Attachment A – Mitsubishi Responses to NRC WJP RAIs

Figure 1 – B-HL Reactor Vessel Nozzle WJP Application

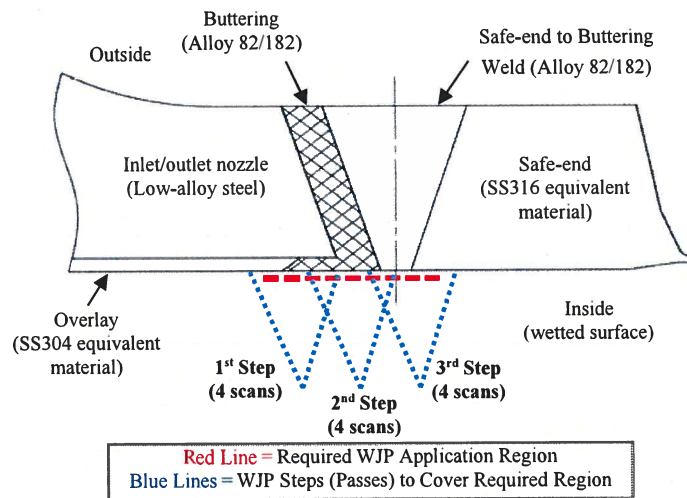
Section 5.2.2 of the relief request discusses peening process. Discuss deviations between the field application and the performance (mock-up) demonstration and/or peening procedure qualification.

A visual representation of a typical reactor vessel WJP application, as it applies to the B-HL at Callaway, has been provided in Figure 1. On this figure, an overlay of the WJP process has been included and identifies the WJP steps and scans required.

The adjusted actual lowest recorded flowrate for this occurrence by the WJP operational software, neglecting the -3.39% accuracy issue, was 46.476L/min [12.278 gpm]. However, once the -3.39% accuracy is accounted for, the actual flowrate was 44.900L/min [11.861 gpm], which equates to an approximate 0.24% deviation from the required minimum 45L/min [11.89 gpm]. This deviation is considered insignificant since the other scanning passes, i.e., scans 1, 3, and 4, at the 3rd step location, the adjusted flowrate was greater than the 45L/min minimum and given the 3 second duration, the region can be considered effectively peened. Furthermore, from the process qualification testing documented in DUS-150319^{Ref. 7} the measurement uncertainty of the utilized flowmeter (for process qualification) was $\pm 0.3\%$ as documented in Section 11.9.7 of Report NS-RPT-100004^{Ref. 8}. Accordingly, the reported deviation of 0.24% is less than to the 0.3% allowed uncertainty from WJP process qualification.

Figure 2 – Image of WJP Application to Plate Versus Pipe with Curvature

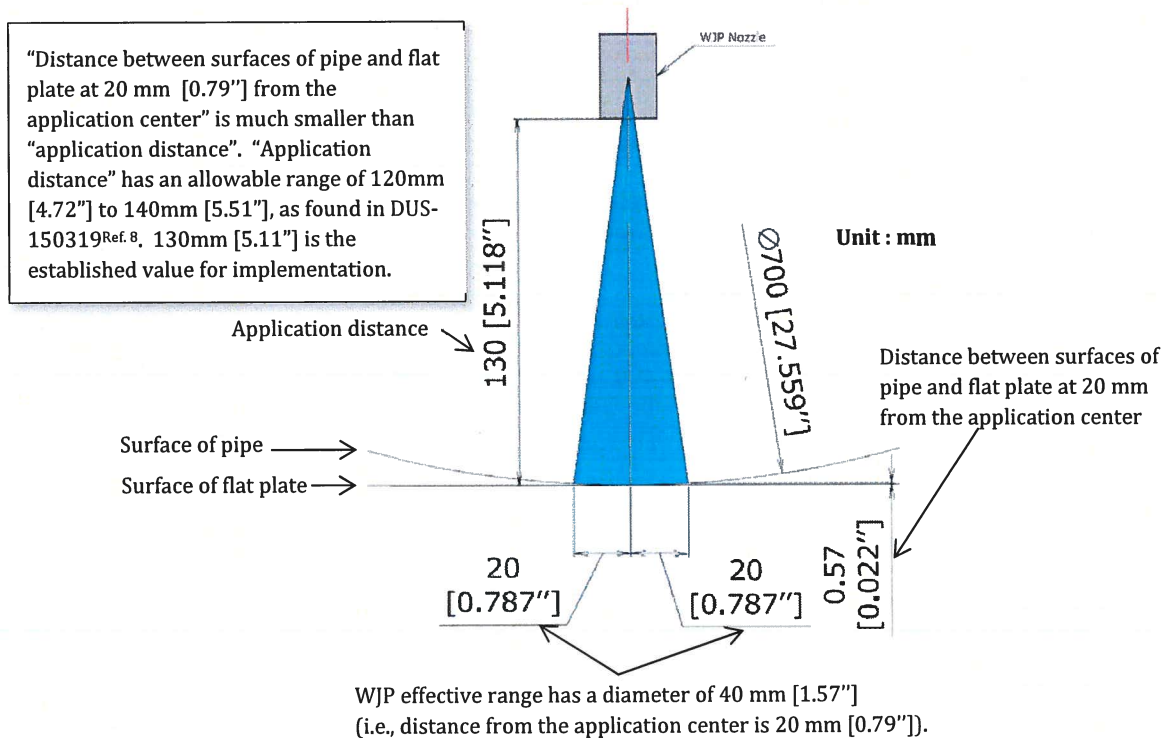
Discuss whether the peening qualification was performed on a mock up that is the same size as in the field (i.e., same pipe diameter and wall thickness). If not, discuss the impact of this difference on the peening applied to the mock-up specimens, and how it will provide the same results as peening on the welds in the field.

The mockup used for qualification testing was not the same size as found in the field. As described in Report DUS-150319^{Ref. 7} it was a flat plate with a thinner cross-section. The flat plate (200 mm [7.87"] × 200 mm [7.87"] × 20 mm [0.78"]) was used because the diameter of the actual reactor vessel nozzle inner diameter is nominally 700 mm [27.56"] and large enough to ignore the curvature when considering the size of the WJP effective range of 20 mm [0.78"] radially (refer to the image below). As shown below in Figure 2, the comparative difference between a flat plate and the inner curvature of the reactor vessel nozzle is 0.57 mm [0.022"]. The effect of this small differences is considered insignificant since the as implemented application distance, i.e., distance between the bottom of the WJP nozzle and the peened surface, was set and controlled at 130 mm [5.12"]; however, qualification testing as it relates to WJP effectiveness was performed at the upper allowable limit 140 mm [5.51"], as found in Report DUS-150319^{Ref. 7}.
